Economic Commission for Europe**Inland Transport Committee****World Forum for Harmonization of Vehicle Regulations****Working Party on General Safety Provisions****121st session**

Awareness of the proximity of Vulnerable Road Users:**UN Regulation No. 159 (Moving Off Information Systems)****Proposal for amendments to Regulation No. [159] (Moving Off Information System for the Detection of Pedestrians and Cyclists)****Submitted by the experts from VRU-Proxi Informal Working Group (VRU-Proxi)***

Figure 1
Set Up for Static Crossing Tests

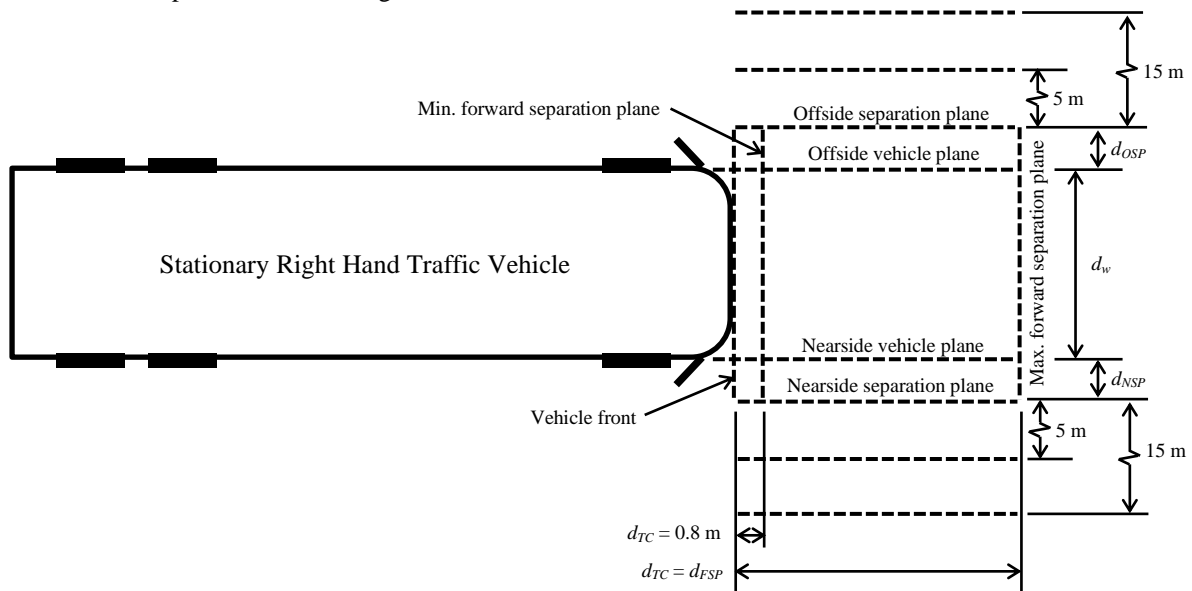
Appendix 1, amend to read:

~~$d_{25\%}$ a distance relating to 25% of the vehicle width.~~

~~d_{LPI} the distance relating to the last point of information (LPI).~~

1. Justifications for paragraph 5.2.2.3.3.: MOIS focuses on straight driving situations. As the testing procedure is not defined, this part of the requirement may lead to too many testing.
2. Justifications for paragraph 5.5.1.: In VRU-Proxi#14, we agreed to use the word initialisation instead of calibration to be in line with the wording used in the AEB regulation. The MOIS (and the AEB) needs driving situations to initialise the system.
3. Justifications for paragraph 5.8.3.: 5.8 deals with failure warning signals.
4. Justifications for Appendix 1.: clarifications of the definitions listed for the table 1 and figure 1.
